Project	IEEE 802.16 Broadband Wireless Access Working Group < http://ieee802.org/16 >
Title	For comment#1012: Adjusting figure 17c – GPCS Layering Model
Date Submitted	2006-05-10
Source(s)	Achim Brandt, Maximilian Riegel Siemens AG Achim.Brandt@siemens.com
Re:	Showing figure 17c explicitly, with the changes proposed in Comment #1012
Abstract	Adjusting figure 17c by removing the boxes representing the interfaces for the particular protocols labeled 'IPv4 over 802.16', 'IPv6 over 802.16', 'IEEE802.3/Ethernet over 802.16', '802.1Q/VLAN over 802.16'. - Rename 'Multiple protocols over 802.16' into 'Multiple protocols encapsulation'
Purpose	For approval as part of Comment #1012
Notice	This document has been prepared to assist IEEE 802.16. It is offered as a basis for discussion and is not binding on the contributing individual(s) or organization(s). The material in this document is subject to change in form and content after further study. The contributor(s) reserve(s) the right to add, amend or withdraw material contained herein.

Introduction

Protocol structure with the Generic Packet Convergence Sublayer (GPCS)

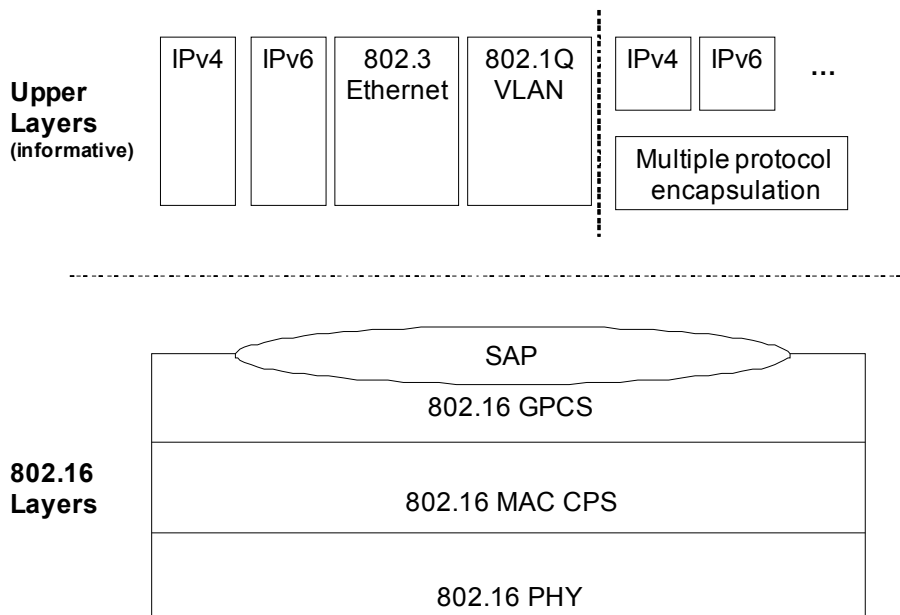
- Adjust figure by removing the boxes representing the interfaces for the particular protocols labeled 'IPv4 over 802.16', 'IPv6 over 802.16', 'IEEE802.3/Ethernet over 802.16', '802.1Q/VLAN over 802.16'.
- Rename 'Multiple protocols over 802.16' into 'Multiple protocols encapsulation'

This contribution shows how **Figure 17c** will look like once this remedy is applied.

Corresponding Change to figure 17c in 802.16g/D2, page 10
